RE: Valle Vista at the Trails, Unit 2 (File: C09D009)
Grading and Drainage Plan, Engineer's Stamp Date 6-23-2014
Revised Grading Plan, (verbally approved) Engineer's Stamp Date 1-20-15
Engineer's Certification Date: 3-18-16

Re: Grading and Drainage Certification, Valle Vista Unit 2
DRB Case No. 1004606, (C09/D009)

VALLE VISTA UNITS 1, 2 & 3
GRADING AND DRAINAGE PLAN

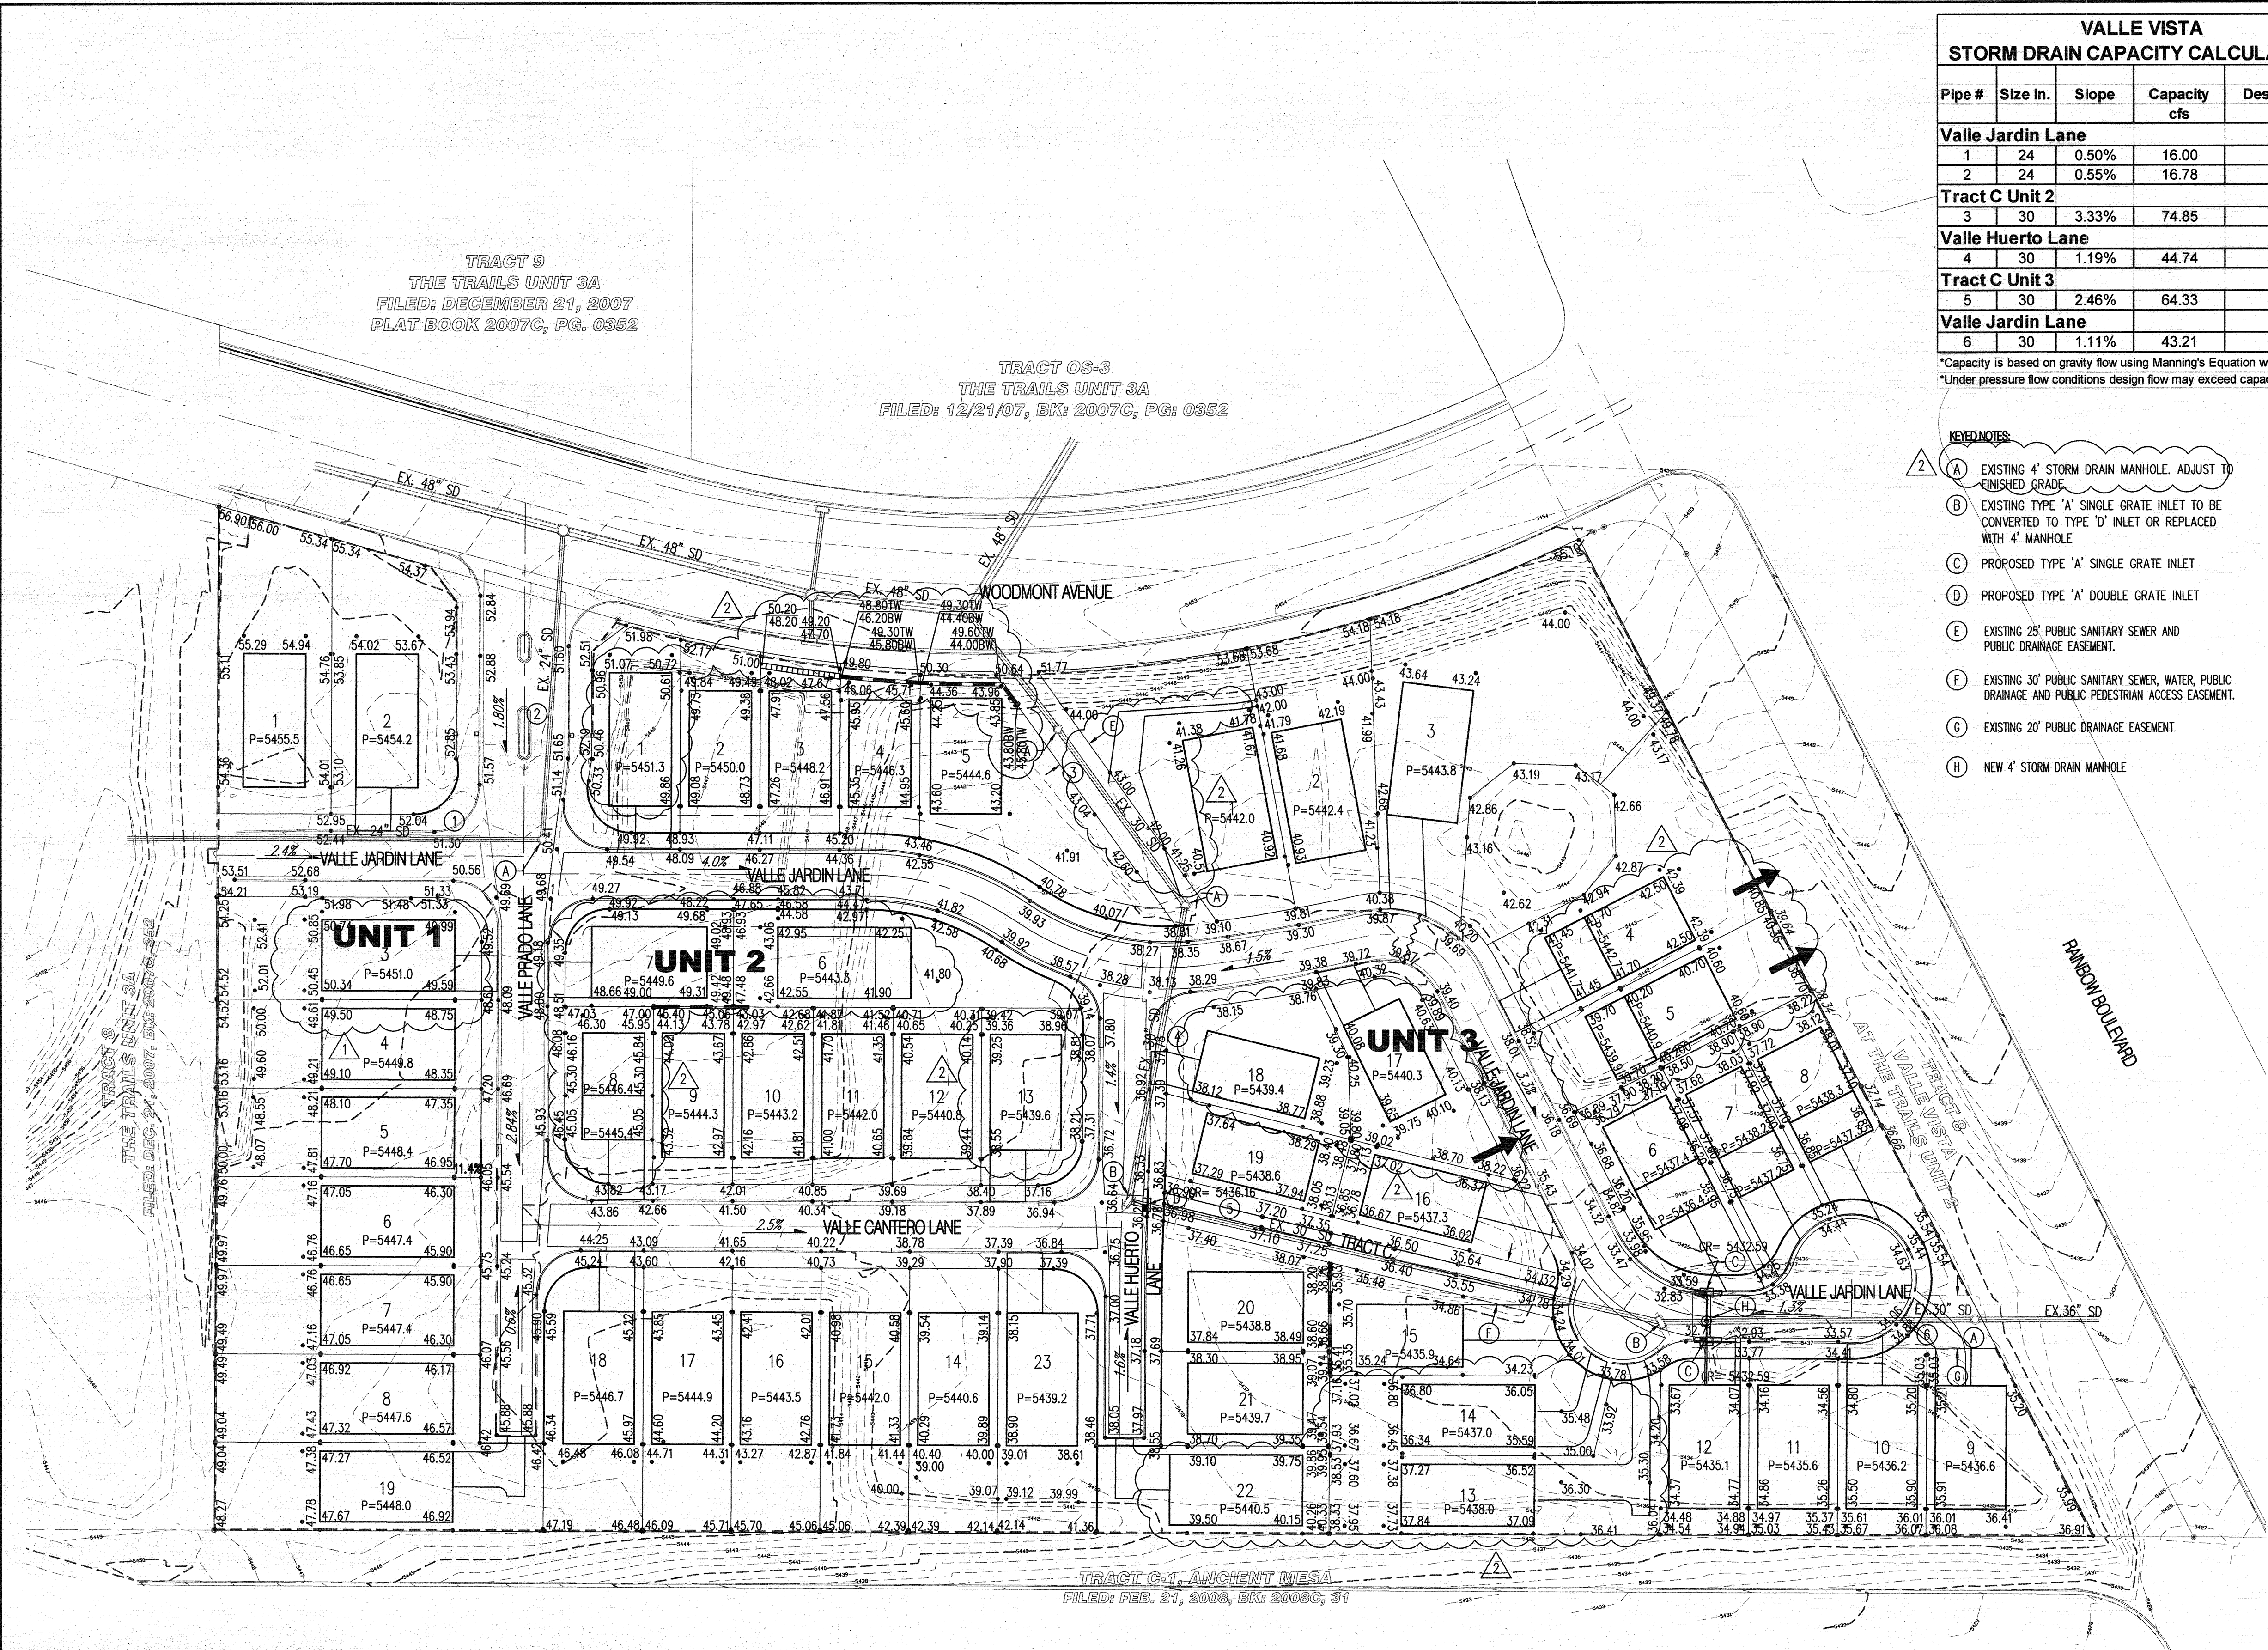
1. *This development discharges to Pond H, and as such the improvements to the Pond must be complete. The orifice plat is intended to allow for an opening of 1.14 SF and needs to resist over 3000 lbs of force without opening. Our field visit shows that the plates are already somewhat opened and need to be completely closed so that the opening does not exceed the 1.14 SF. The pin seems to be undersized. Show that the pin provided can maintain the plates remain completely closed under the 3000 lbs of force. Show that the pin will not shear with this amount of force. See attached picture. **It is my understanding that issues have been resolved and that at a subsequent field meeting with Rick Beltramo you stated that the Pond H improvements were acceptable.***

2. *The retaining wall at the rear of Lot 5 appears to have collapsed. **As previously discussed, the retaining wall has not collapsed, but actually turns an approximate 45 degree angle and steps down the slope.***

3. *Manhole is SD Tract east of Lot 5 needs to be adjusted to grade. **The manhole has been adjusted.***
4. *Lot 3 rear retaining wall is intended to be a garden wall retaining 2' to be built by the homebuilder. However, what mechanism is in place for the City to ensure that such a wall is built? If no such mechanism is in place, this wall should be constructed prior to Release of Financial Guarantee. Furthermore, should the garden wall not be built, the existing wall beyond is susceptible to overturning since the supporting soil is not in place. **The 2' garden wall has been built, see as-built elevations on the grading plan.***

5. *The split between Lots 7 and 8 is over 2', and needs a retaining wall per the plan. **See the revised grading plan dated 1/20/15. The split is 2' or less, which will be built as part of the garden wall by the homebuilder.***
6. *The split between Lots 6 and 7 is over 4', and needs a retaining wall per the plan. **See the revised grading plan dated 1/20/15. The property line split is 2', with a slope in the rear yard. The 2' split will be incorporated in the garden wall, which will be built by the homebuilder.***
7. *Valley gutter at intersection of Valle Prado Lane and Valle Cantero Lane is chipped along an edge, and the asphalt is not flush. **The valley gutter is part of the Unit 1 infrastructure which has been accepted by the City. In addition, the streets in Valle Vista are private.***
